**DEVIATION REQUEST  
AND DECISION FORM**

Project Name : The Commons at Falcon Field      Deviation No. 5 (1<sup>st</sup> Submittal)      Date: 2/7/2024 rev. 4/3/2024

**DEVIATION No. 5 – rev. 4/3/2024 - Modified Urban Non-Residential Collector Cross Section and Design Standards by Functional Classification (Urban Non-Residential Collector)**

Deviation Exhibit 5-1

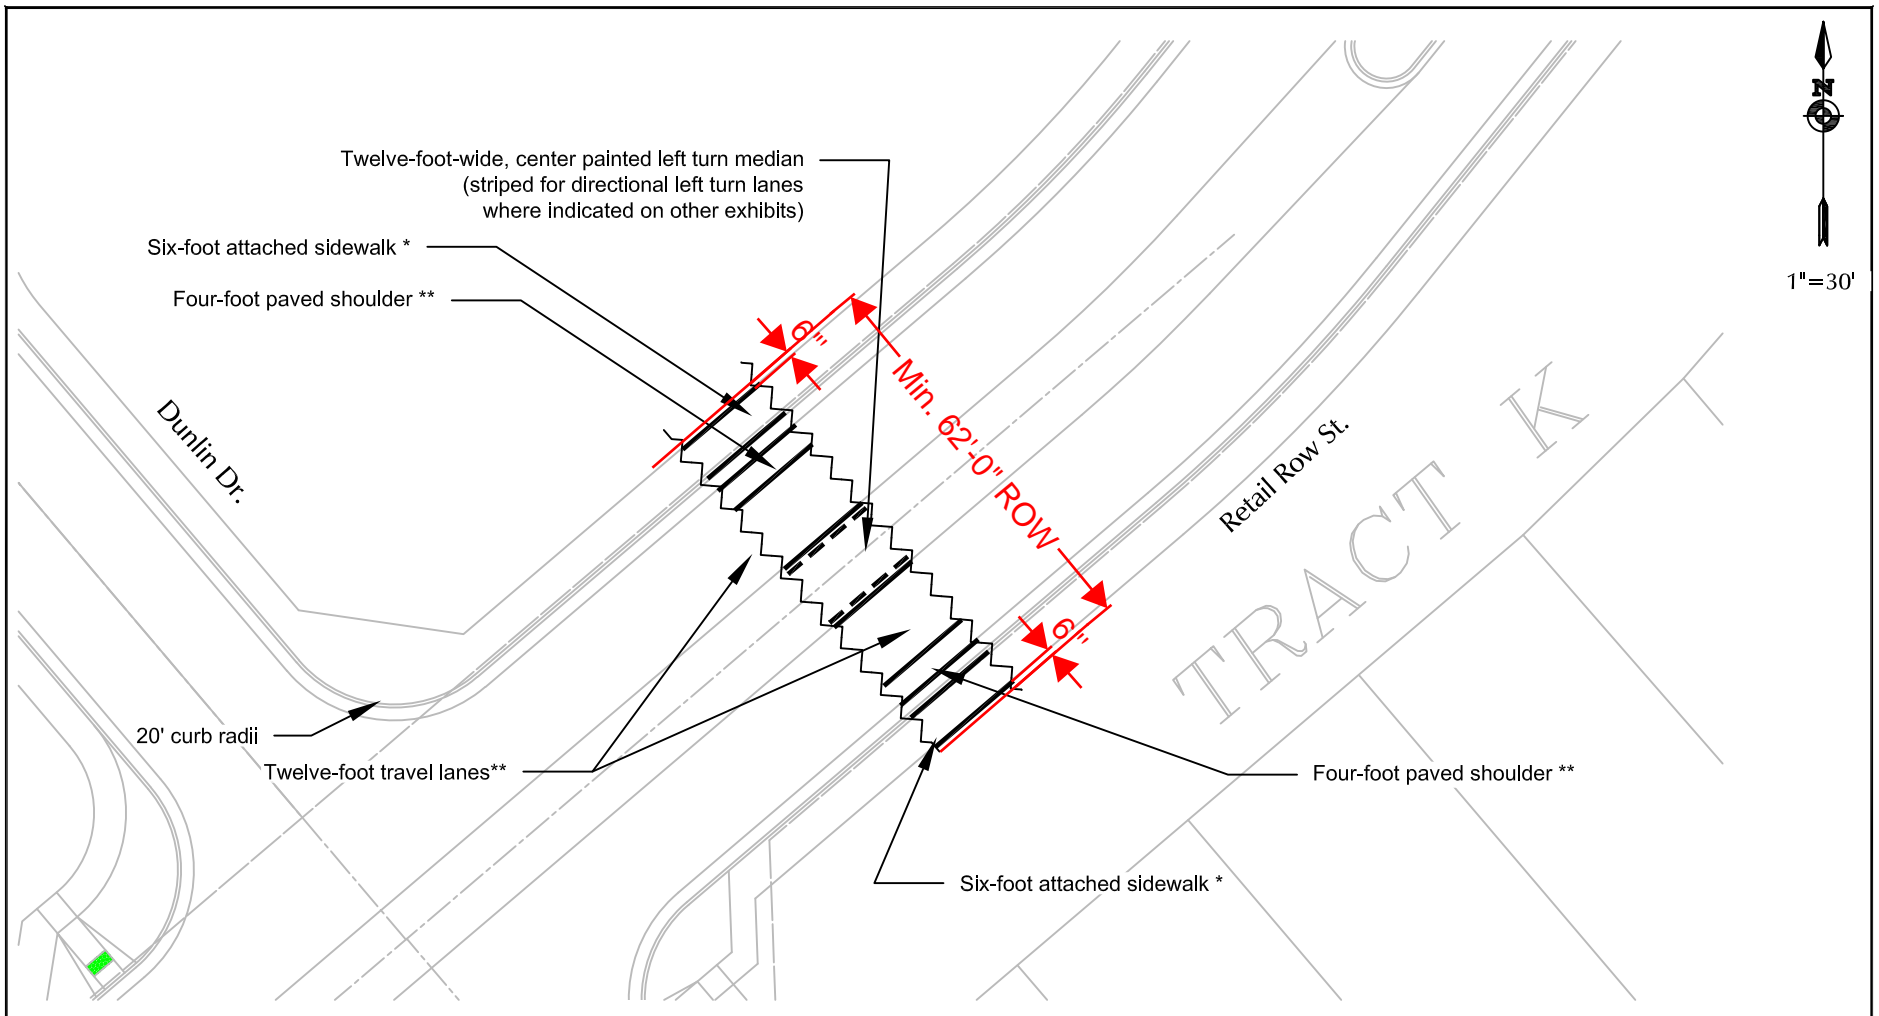
ROW width shall be a min. 62 ft. such that the sidewalks are located within the ROW and 6" from the ROW boundary line. Please see comments on exhibit 5-1.
